RE: **CAO23-030** Review Letter 1; 5300 Butterworth Rd, Mercer Island, WA 98040

The City of Mercer Island Community Planning and Development Department has completed a review for compliance with the zoning code, Title 19 of the Mercer Island City Code (MICC) for the above Critical Area Review 2 application. The following issues need to be addressed in your resubmission:

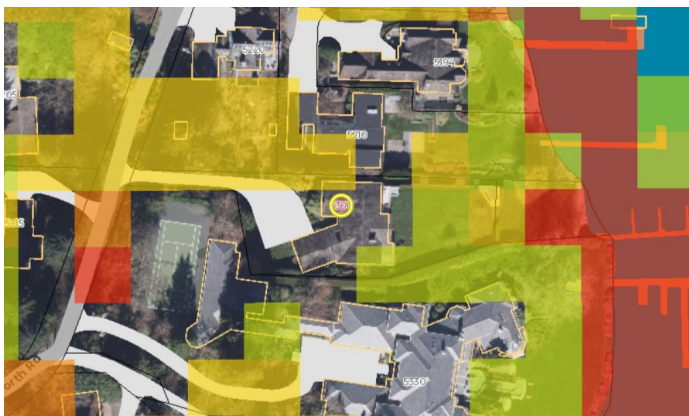
1. All Geotechnical Peer Review comments by Michele Lorilla under the associated building permit (2312-032) must be addressed under this Critical Area Review 2 application.
2. The properties to the east and west contain areas that are mapped as a high probability for a wetland (see image below). Provide documentation prepared by a qualified professional for the verification of the presence or absence of a wetland in these areas. (Red = High Probability, Orange = Moderate-High, Yellow = Moderate, Yellow/Green = Low-Moderate, Green = Low)
